ATTACHMENT TO LICENSE AMENDMENT NO. 180

FACILITY OPERATING LICENSE NO. DPR-52

DOCKET NO. 50-260

ATTACHMENT TO LICENSE AMENDMENT NO. 181

APRM Flow Reference Scram and APRM Rod Block Settings
Fig. 2.1-1

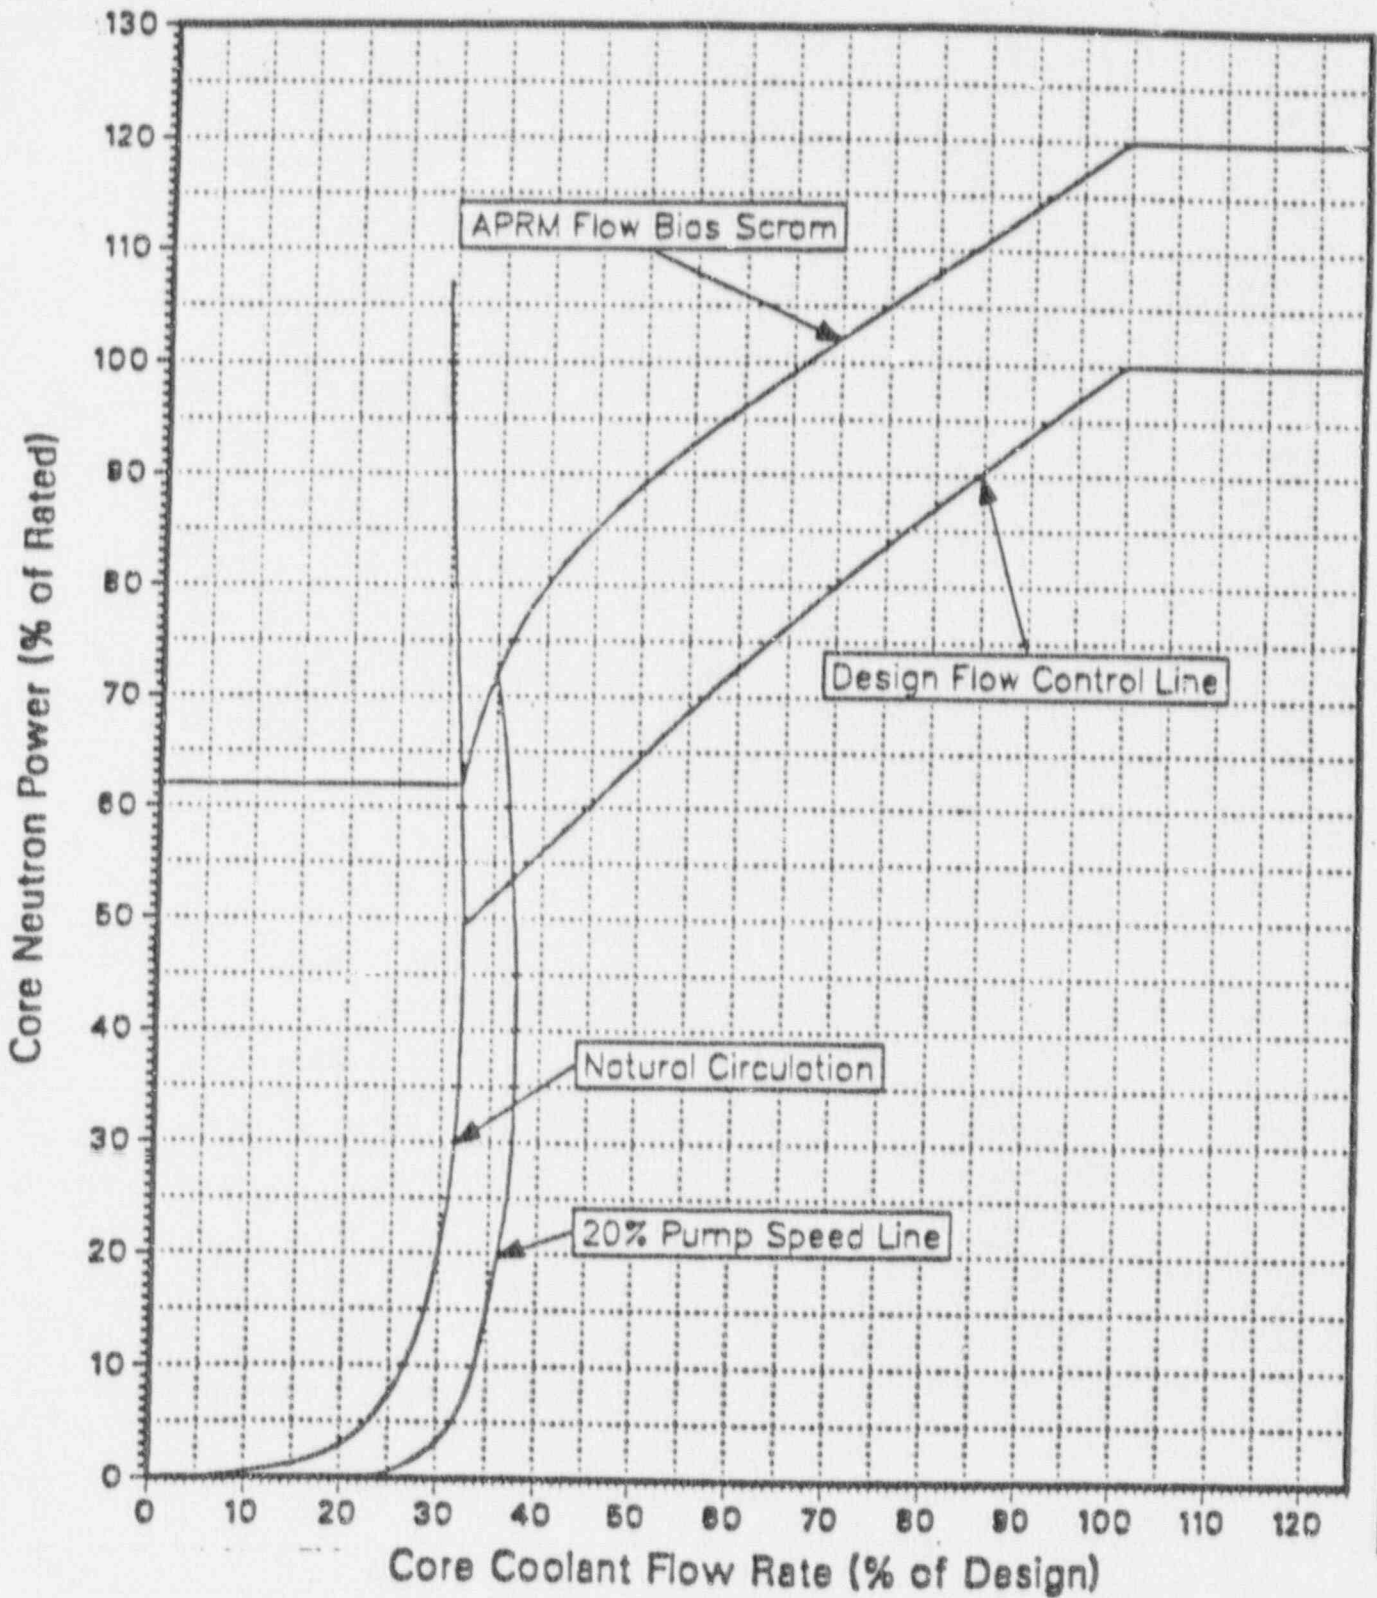
- c. The APRM Rod Block trip setting shall be:

$$S_{RB} \leq (0.58W + 50\%)$$

where:

S_{RB} = Rod Block setting in percent of rated thermal power (3293 MWt)

W = Loop recirculation flow rate in percent of rated (rated loop recirculation flow rate equals 34.2×10^6 lb/hr)
